# Amigo Bangladesh Ltd.

RS No: 1408 - 1416, Khalapara, Dakkhinbag, Kaliganj, Gazipur-1613  
(23.951914, 90.613541)

3<sup>rd</sup> & 11<sup>th</sup> October 2021

Missing bolt

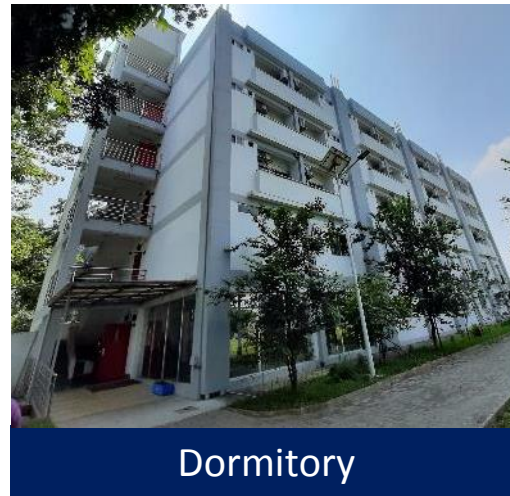
Factory Engineer is required to find the missing bolts and install the bolts as per specification.

Column Layout Plan

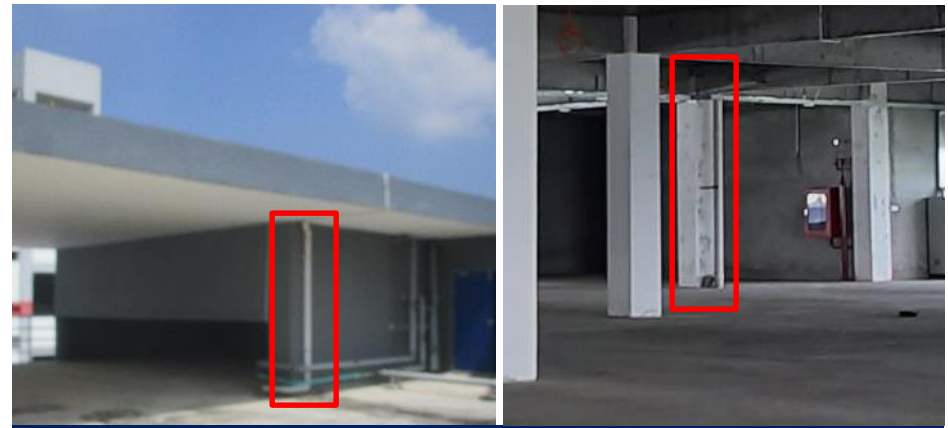
**Column stress exceeds normal design limit**

Cursory calculation indicate that the working stress of the marked columns exceed the normal design limit due to O.HWT and large span(8m) considering 3 kPa live load on typical floor, 1.5 KPa live load on roof and 16.37 MPa concrete strength. As part of Engineering Assessment (EA), factory engineer is required to verify the in-situ concrete strength, check the column capacity and suggest proper remedial actions accordingly.

Gable frame

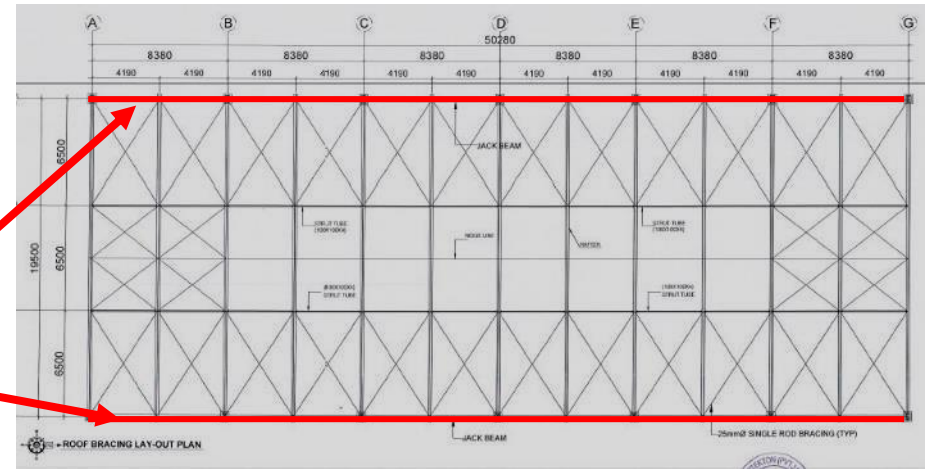
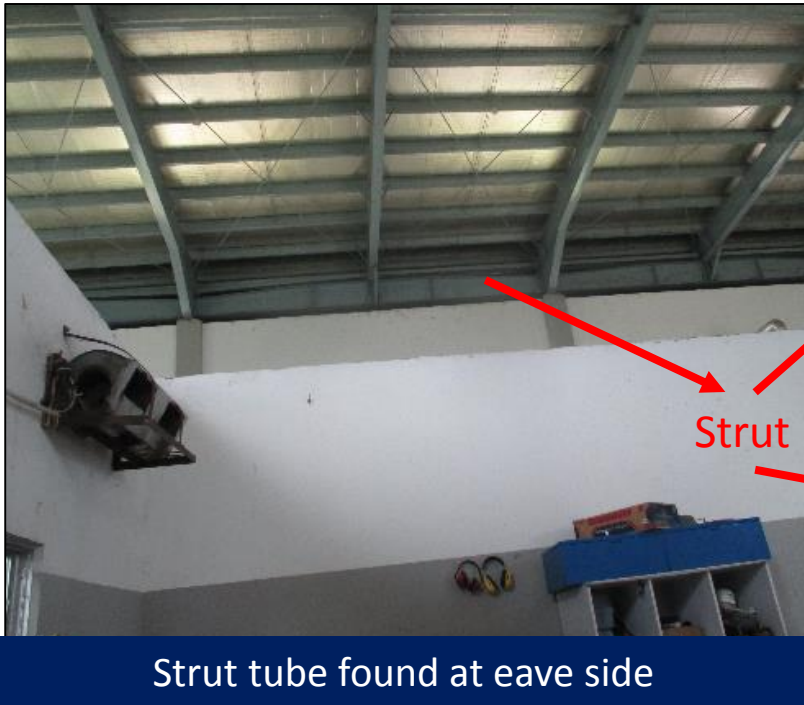
No connection details were found at red marked portion in drawing. Building engineer is required to update the as-built drawing.

Outside stair & pedestrian platform

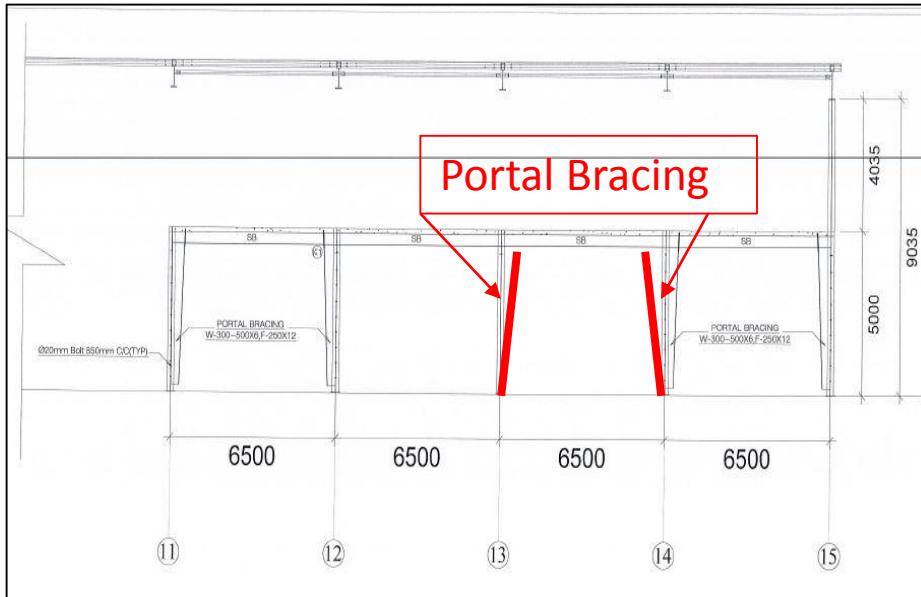
At grid 15, column & rafter connection is not shown in drawing as well as outside stair details not found in drawing. Building engineer is required to update the as-built drawing.

Portal bracing layout

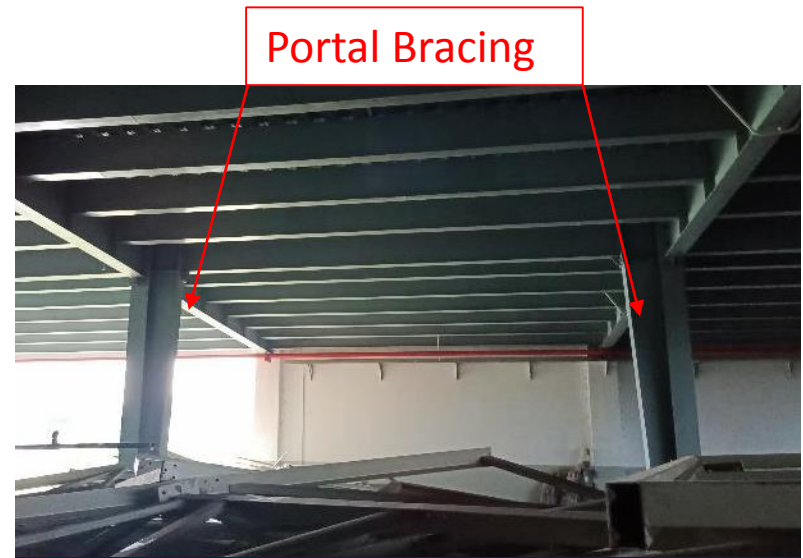
Portal bracing were found at grid 13~14 whereas in drawing there is shown at 14~15. Also, Steel main beam is connected to RC beam at Grid-15. But as per drawing steel main beam is connected to RC column. Building engineer is required to update the as-built drawing.
